Technical Service Bulletin

Topic	Steering malfunction message displayed on dash, DTC 'C10AC07-Steering mechanical malfunction' stored
Market area	Bentley: worldwide (2WBE),Hongkong-Macau (5HK)
Brand	Bentley
Transaction No.	2051802/2
Level	EH
Status	
Release date

Steering malfunction message displayed on dash, DTC 'C10AC07-Steering mechanical malfunction' stored

Figure 1

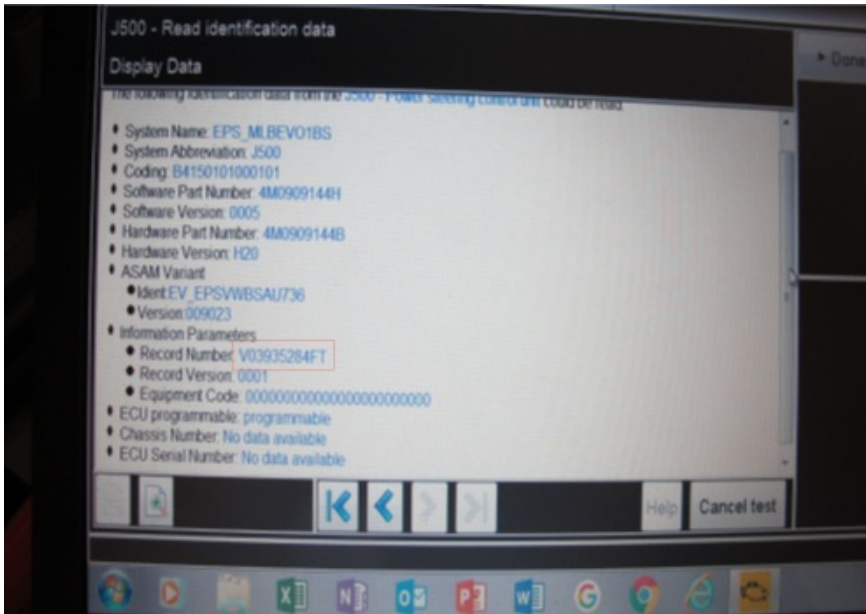
After completion of **either** procedure, check that the parametrization has been successful;

- **ODIS tester:** → Address 44-Steering assistance → Guided Functions → Read identification data

Under the title **Information Parameters**, the **Record Number** should end in suffix **FT**, see *Figure 1*. This confirms the procedure has been successful.
